Construction Division
Additions & Alteration Charges Approval Form

Company Name:	MRMLLP	Site	Gulmohar Residency
Name of the customer	Asha Fatima		
Villa/ Flat No.	F-603..		
Sl.No	Description	Amount	
1	Total extra Charges	-	
2	Total refundable amount	46,819.	
3	Net amount to be charges (if any)	-	
4	Net amount to be refunded (if any)	46,819.	
Remarks :			
Approved by Project Manager		Approved by Design Team	
Date		Date	
Sign: 		Sign:

GULMOHAR RESIDENCY

Details of Additions & Alterations

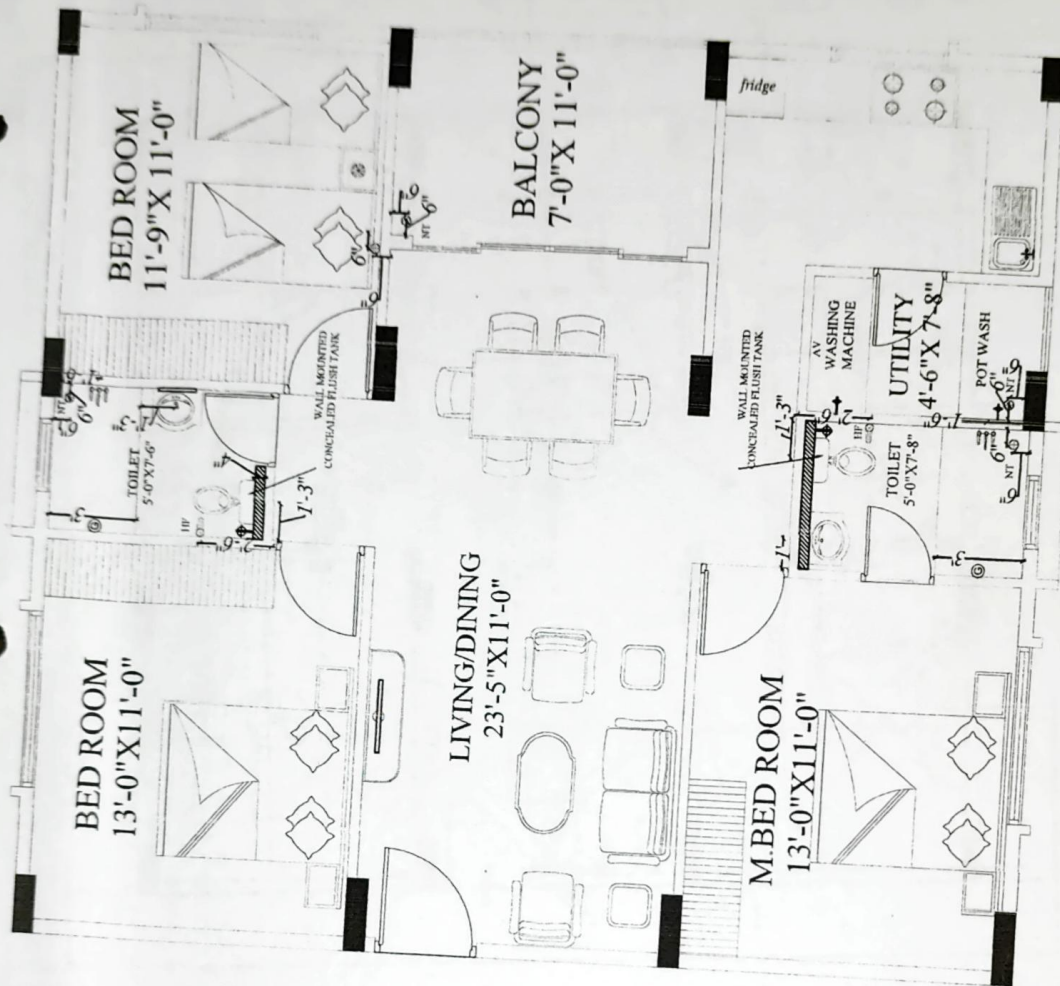
Other Changes:

1) shown as plan

Description	Direction	Owners & Developers :	Date :	21.09.2020	Promoted by	
	N	Modi Reality Mallapur LLP	Prepared By :	Jayapradha	Modi Properties Pvt Ltd	
		Project Name & Phase :	Approved By :	Soham Modi		
		Gulmohar Residency	Scale :	N T S		
		ELECTRICAL PLAN -1360 sft FLATS-A2 TYPE

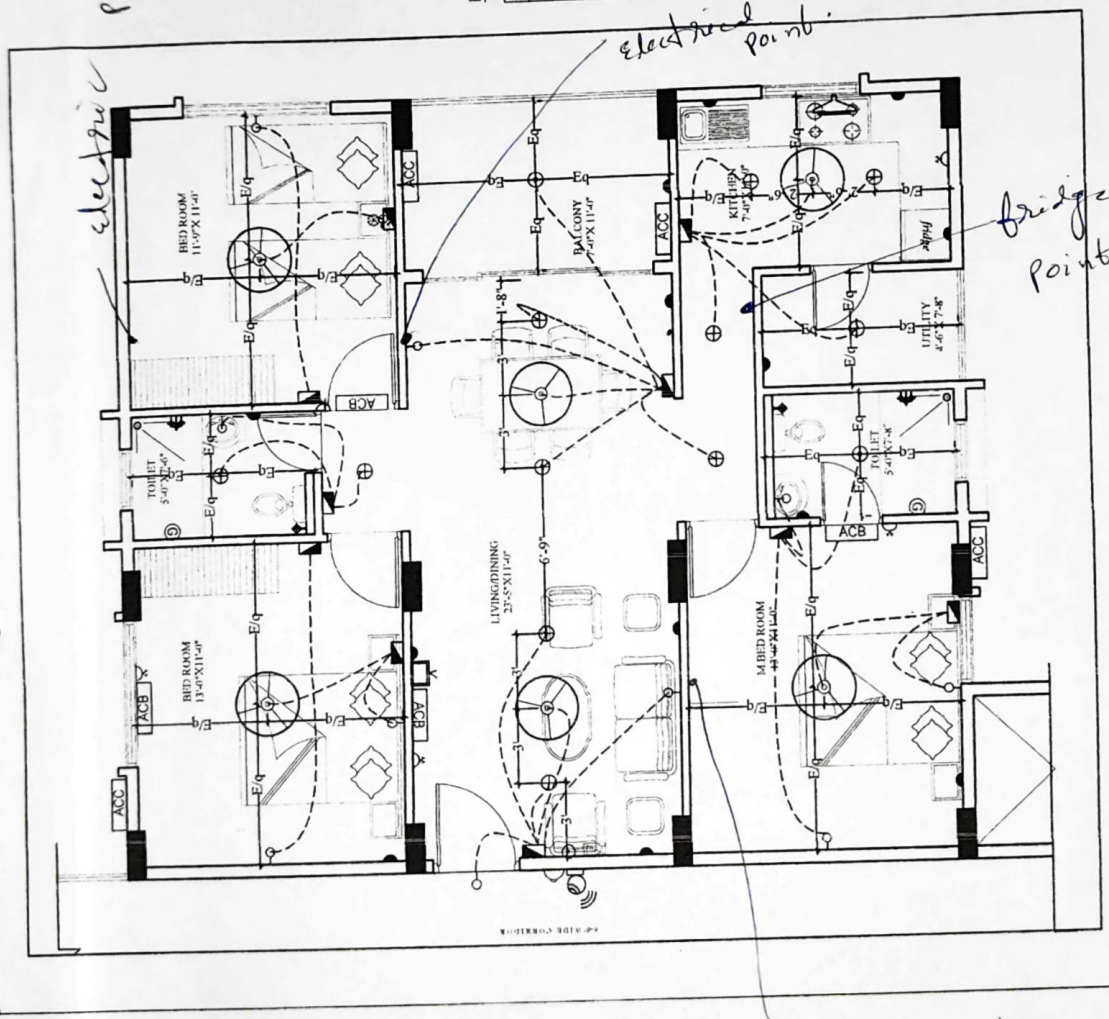
Changes in electrical points: (mark on plan)

1) shown as plan

point

electrical point

bridge points

electrical point
